# Amendment C193yrn – Yarra Ranges Shire

Kinley Estate Development Proposal  
Transport Review Statement

Prepared by: Chris Coath of GTA Consultants (VIC) Pty Ltd for Russell Kennedy Lawyers

Reference: V159104

Figure 4.1: John Street Context (extent shown in green)

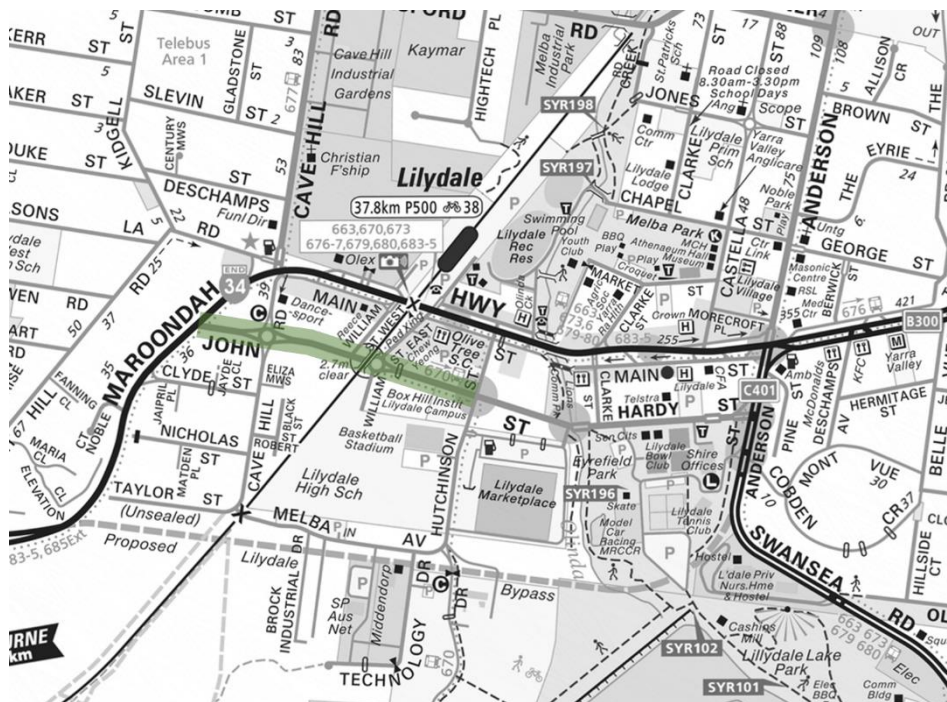
The proposal to add traffic to John Street to accommodate the traffic impacts of the development proposal is inconsistent with the role of John Street at present and in the short term (school route and public transport route). It is also inconsistent with the longer-term objectives that John Street serves as a second “main street” for Lilydale.

It is industry practice that strategic developments should primarily rely on the highest order roads that are reasonably available. If vehicle capacity is to be added to the road network, it is reasonable to add it at arterial roads, fulfilling their primary movement function, rather than adding vehicle capacity to minor roads and intersections, where to do so would be at odds with their amenity-based function.

Therefore, in a “competition” that concerns where to add new intersection capacity, the intersection at Maroondah Highway/John Street comes second to the higher-order intersection at Maroondah Highway/Hutchinson Street. Further, the reassignment of traffic around the John Street/Hutchinson Street intersection may result in a different intersection geometry outcome – as the reassigned development traffic switches from left and right turns into simply north-south through movements.

Figure 5.7: Hutchinson St / John St Intersection Layout – Post Development Revised Layout

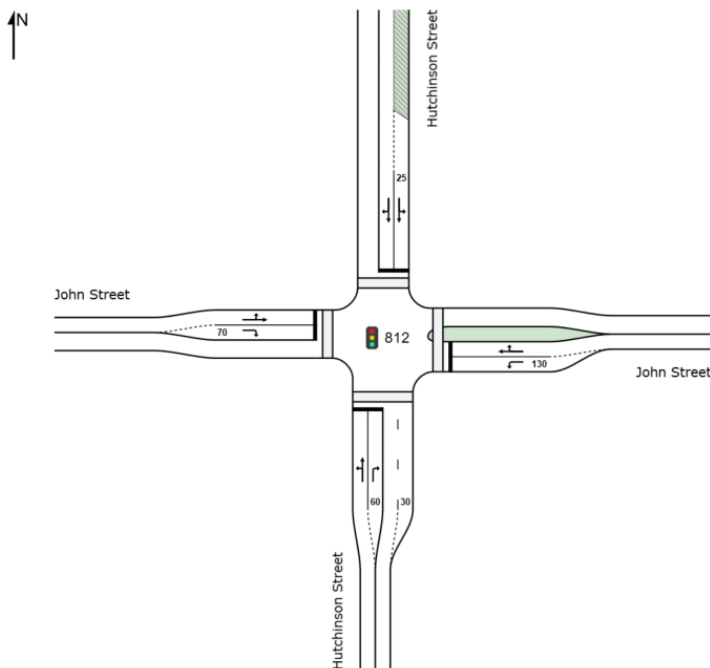
The layout evaluated as a part of the 'post development' traffic assessment at the intersections of Hutchinson Street / John Street is shown in Figure 5.7, with the results of the assessment outlined in Table 5.4

Figure 5.13: Hutchinson St / John St Intersection Layout – Post Development Traffic Redistribution

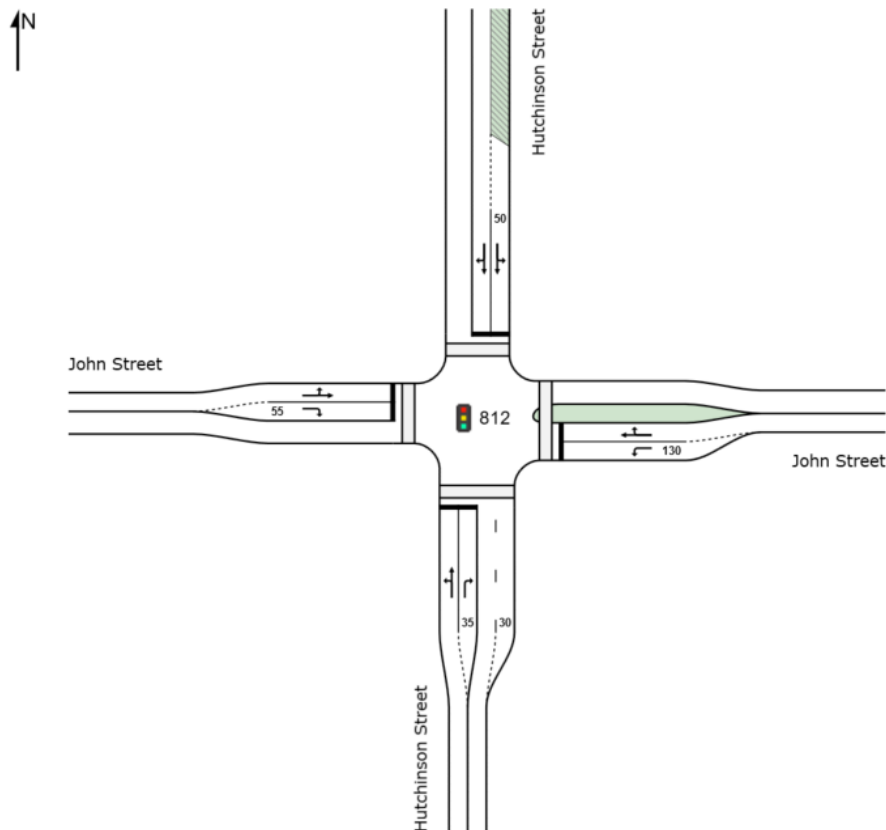
The redistribution of traffic resulted in some minor modifications to the existing intersection geometry being required at the intersection of Hutchinson Street and John Street (being the loss of some three (3) parking spaces on the northern intersection approach). The revised layout is shown in Figure 5.13 with the results of the revised traffic assessment at the intersection shown in Table 5.11.
